MEMO

SUBJECT: Ezone Project Site-Specific Testimony and Staff Responses

10701 SW 25th Ave – Proposed Edit to Natural Resource Mapping:

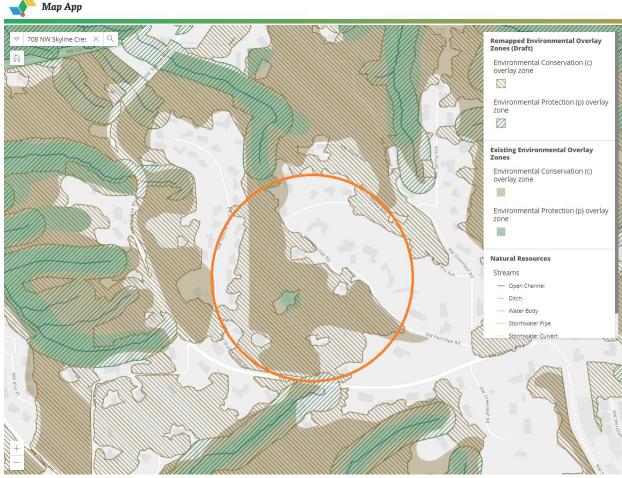
Testimony: Do not expand the ezones on the site because it will impact the ability to subdivide the site in the future and will decrease property value. Don't change ezone mapping on this site because ezones would prevent the owners from building houses that would help to reduce the citywide housing shortage. Honor the existing land use decision by maintaining the ezones in their current location. It was also noted that there is stormwater runoff that is coming onto the site from the existing SW 25th Ave cul-de-sac, and that if the road was built out as would be required as a condition of approval of the land use review, there would be new stormwater facilities that would be designed to handle the runoff that currently discharges onto the property. Testimony ID #331563, #331562, #331564, #331565, #331566, #331567, #331568, #331570, #331571, #331572, #331473, 331476

Staff Response: The conservation zone is applied to portions of mapped forest patches that are contiguous to streams. Ezone Project staff have reviewed the existing adopted ezone maps and the adopted natural resource protection decisions that apply to resource site SW18, and they do not believe that adopted policy is to only apply conservation zone to forest vegetation that is located on land that slopes toward particular streams. The forest vegetation provides a variety of ecosystem services. One of the most important is retention, filtration, and infiltration of stormwater, that would otherwise turn into surface runoff and flow directly into streams or sewer systems. But the forest vegetation provides a variety of other ecosystem services, as well. These include moderation of temperatures and reduction of heat island effect through shading and evapotranspiration, stabilization of soils and prevention of erosion. And the forest vegetation serves as habitat for wildlife and provides migratory pathways and habitat connectivity. Many of these ecosystem services are in no way dependent on whether or not the angle of the slope of the land on which the forest vegetation is located is angled in the direction of a particular stream.

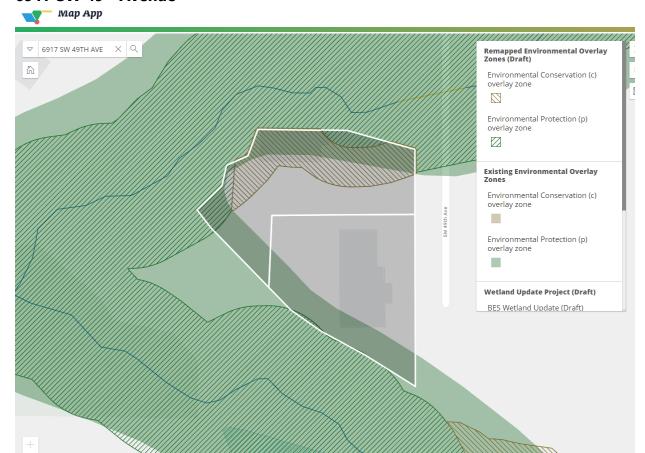
Testimony: The property owner contends that because a wetland determination on nearby lots resulted in modifications to wetland mapping on those lots, the wetlands that are mapped on his lot should be removed from the inventory. Testimony ID #331408

Staff Response: BES is doing a citywide Wetland Inventory Project. The results of their wetland mapping have been provided to the Ezone Project. Ezones are applied to the mapped wetlands according to existing adopted policy. During the hearings process at the PSC, the PSC voted to apply minimum protections to all wetlands in all resource sites, and to add the results of BES wetland mapping to the Ezone Project natural resource inventory.

There are multiple streams that run through a natural area to the north of 4919 SW Texas. BES's preliminary wetland mapping showed that there was a large wetland complex that stretched across several different lots in the area around the streams. The wetland on 4919 SW Texas was part of the larger wetland complex.

BES, and their consultants, SWCA Environmental, did a series of site visits in the neighborhood at the request of several different property owners. Each of the site visits looked at different parts of the wetland complex. Some of the draft wetland mapping was confirmed through field verification, while other site visits resulted in the deletion of portions of the wetland complex.

At the request of the property owner, BES employees visited 4919 SW Texas in February of 2022 to review the wetland mapping. The BES employees did not provide a final determination on whether or not the feature is a wetland, but they determined that there are hydric soils and vegetation growing in the area that is capable of surviving in a wetland. Therefore, an additional field verification would be needed before a final decision could be made on the wetland mapping. BES has contracted with SWCA Environmental to do free wetland field verifications at the request of property owners. They will be working between March and June, and they plan to continue to offer free wetland field verifications in future years.

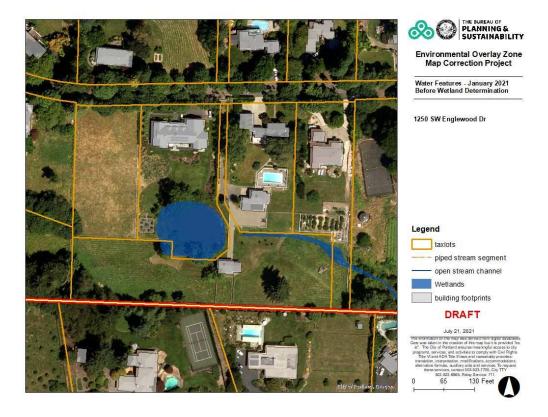
Testimony: The property owner contends that the wetland that has been identified, and field verified on the site is not actually a wetland. The owner argues that application of the p-zone in this area will adversely impact their ability to maintain and alter the existing gravel road, loading pad, flag road for the southern lot, and firetruck turnaround. The property owner also contends that they have been unable to review the soil and plant data that were used to make a wetland determination on the site. They also say that they have not received any response in regard to

Staff Response: Project staff visited the site and met with the homeowners in August of 2020. Since the site visit, staff have continued to have email correspondence with the property owners and have responded to all questions and inquiries promptly.

The wetland mapping on the site was field verified by employees of SWCA Environmental in accordance with the protocols that have been employed in the Wetland Inventory Project. At the request of the property owner, Bureau of Environmental Services staff provided data sheets and maps that were produced by SWCA staff to document the onsite wetland determination. These records were transmitted as email attachments to the property owner on July 22, 2021.

The wetland determination data sheets note the existence of wetland hydrology, redoximorphic soil conditions that indicate seasonal saturation, and hydrophytic plant dominance in two of the six study plots that were tested by SWCA staff. The results of the field sampling were used to modify and verify the wetland mapping on the site. Wetland mapping was adjusted or deleted in areas where wetlands were not confirmed to be present, and they were retained in locations where wetland mapping was field verified. The wetland appears to be the headwater of a tributary that flows into Tryon Creek.

Property owners that disagree with wetland mapping that has been field verified may conduct an independent wetland delineation on their property. If the results of a wetland delineation conflict with wetland mapping in the Natural Resource Inventory, and if the Oregon DSL concurs with the results of the delineation, the results will supersede the previous wetland determination and the wetland inventory will be modified accordingly.

4855 SW Hewett - Proposed edits to natural resource mapping:

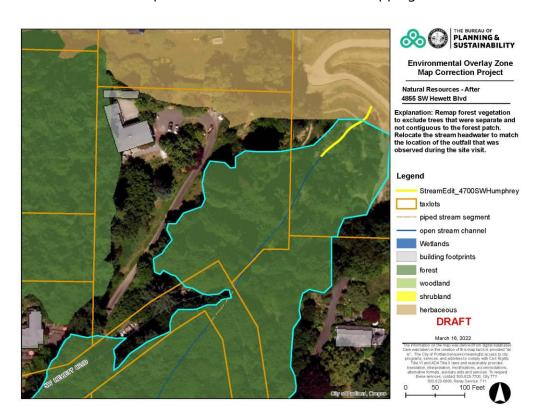
Testimony: The property owners expressed concern that the proposed ezones could make it difficult to divide the lot or do additional development on the site. They said that they were worried about the cost of permitting for new development on sites with ezones. They also expressed concern about how the proposed ezones could impact the value of the property. Testimony ID 331480, 331583

Staff Response: Staff visited the site and found that the vegetation mapping appeared to have some errors on the site. Staff are proposing edits to reduce the coverage of the mapped forest canopy on the site. If the changes to the vegetation mapping are adopted, the amount of area that would be covered by the draft ezones would be reduced.

4710 SW Hewett - Proposed edits to vegetation mapping:

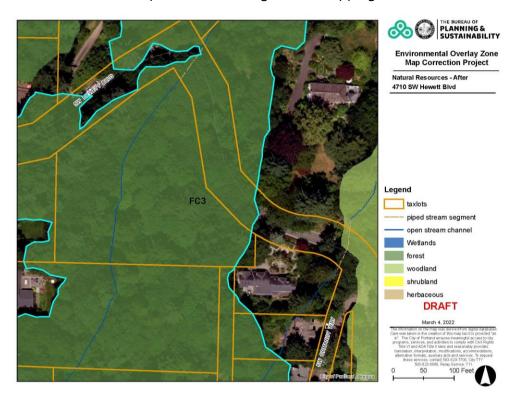
Testimony: The property owner expressed concerns about rules and regulations that apply to managing trees and vegetation in the environmental overlays. They said that they thought that the protection zones were mapped correctly on the site, but they were worried about the accuracy of the conservation zone mapping. Testimony ID 331561

Site Visit: Yes, 3/3/2022 Project staff made edits to the forest vegetation mapping on the site. If these edits are adopted, the area that is covered by the draft conservation zone on the developed lot will be reduced.

Staff Response: The ezones would not prevent the division and development of the vacant lot, but they could potentially constrain the area where development could occur. Development would need to be concentrated on the eastern half of the vacant lot, away from the stream. The lot could potentially be developed at the maximum density that would be allowed by the land division code that applies to the R20 base zone, but the lots sizes might need to be reduced to achieve maximum density. Other provisions in the zoning code, building code, or requirements for public improvements that have nothing to do with ezones could also impact the ability of property owners to subdivide and develop to the maximum allowed density.

4650 SW Ormandy - Proposed edits to natural resource mapping:

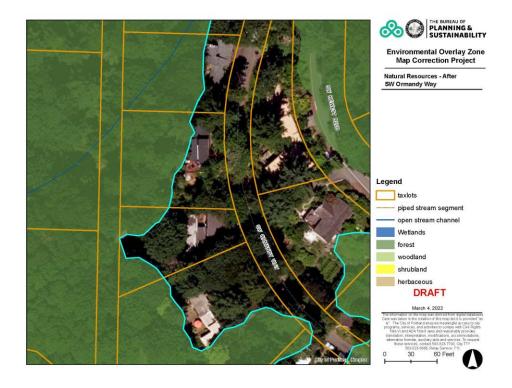
Testimony: The property owner testified that there is already a protection zone that applies to the lot and that they feel the proposed conservation zone is too expansive. They are concerned that the proposed ezones would make it too expensive to remove dying trees that are near the house. Testimony ID 331550

Site Visit: Yes, 3/3/2022 As a result of the site visit, project staff are proposing edits to the forest vegetation mapping, which, if adopted, would reduce the draft conservation zone coverage on the lot.

Staff Response: After visiting the site, project staff concur that the forest vegetation mapping on the site covered too much area. Staff are proposing to reduce the area that is mapped as forest on the site.

5115 SW Westwood – Proposed edits to natural resource mapping:

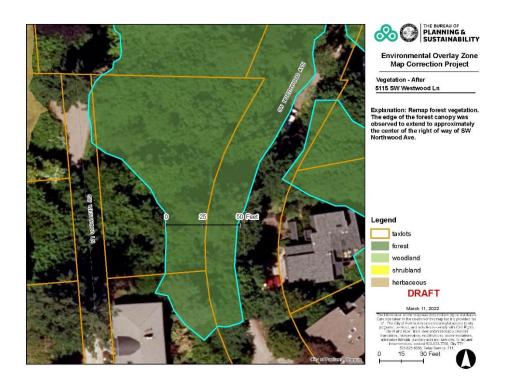
Testimony: Lots on all sides of the vacant lot have already been built out. There isn't anything special about the forest vegetation on the lot. Remove the ezones from the vacant lot to make it easier to develop. Ezones proposed on the site make the lot uniquely challenging because a strip of transition area wrapped all the way around the lot. Because of this, the standards were almost impossible to meet on the site and any potential development on the site would likely trigger environmental review.

Site Visit: Yes. 3 site visits. The most recent was 3/11/2022. Staff made edits to vegetation mapping to follow the dripline of the forest canopy and to exclude areas of sparse trees and low structure vegetation from the mapped forest canopy.

Staff Response: After the first site visit, staff reviewed the vegetation mapping on the site and they deleted areas from the mapped forest canopy where there were gaps between the trees and areas of lower structure vegetation. After the second site visit, staff identified an area in the southwest corner of the vacant lot where there were only dead trees and no observable forest canopy. They deleted this area from the mapped forest patch. After the final site visit, staff found that the dripline of the forest patch that overhangs SW Northwood Ln appeared to extend too far into the right of way. The edge of the forest patch was edited to match what was

observed on the site, which is that the forest patch only extends to roughly the center of SW Northwood Ln.

1215 SW Hessler - Proposed Edits

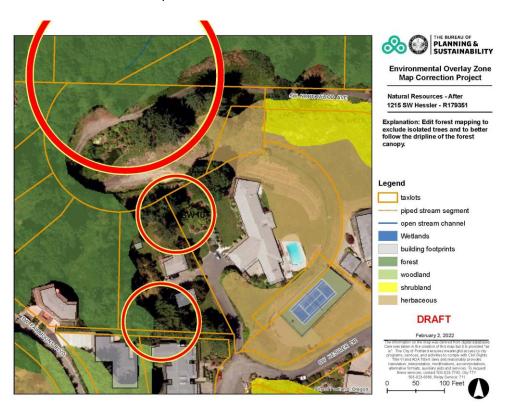
Testimony: Testifier claimed to have been unaware of the Ezone Project and questioned whether adequate notice was provided of hearings on the Ezone Project. The testifier raised several issues regarding how ezones impact properties: The testifier questioned whether ezones would impact property values or restrict property owners' abilities to do new development on their lots.

Four specific requests were made: 1. Delay the approval of the project 6-12 months; 2. Allow property owners to hire private consultants to draw up individual natural resource protection plans for their lots; 3. Allow project staff to work with homeowners to balance development and natural resource protection decisions; 4. Allow staff, City Council, and the mayor to engage in negotiations with individual property owners one on one to decide where ezones should be applied. Testimony ID 331462, 331580

Staff Response: The Ezone Project has been ongoing for 3.5 years. During that time, a series of mailings were sent out to all impacted properties, and project staff hosted open house meetings and attended neighborhood association meetings that were attended by hundreds of Portland residents. The mailing address that is associated with several properties that are owned by Mr. Schnitzer was sent mailings in 2019 and 2020. Project staff also posted an online map that would allow property owners to review the proposed changes to the ezones on their sites. The Ezone Map App has been online for public review since August of 2018.

3300 SW Evergreen Ln – Natural Resource Mapping Before Site Visit:

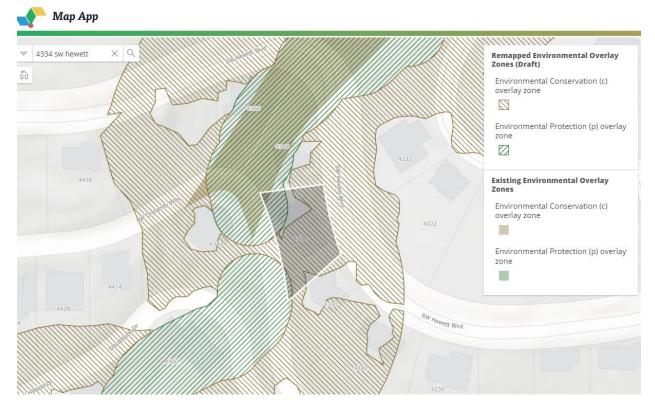
Testimony: The testimony questioned the use of aerial imagery to map forest vegetation and asked for more time to allow property owners to work with Ezone Project staff to make sure maps are accurate. Testimony ID 331465.

During the site visit, project staff reviewed the natural resource mapping and proposed edits to the mapped forest vegetation. If these edits are adopted, the draft conservation zone will shrink slightly on the site.
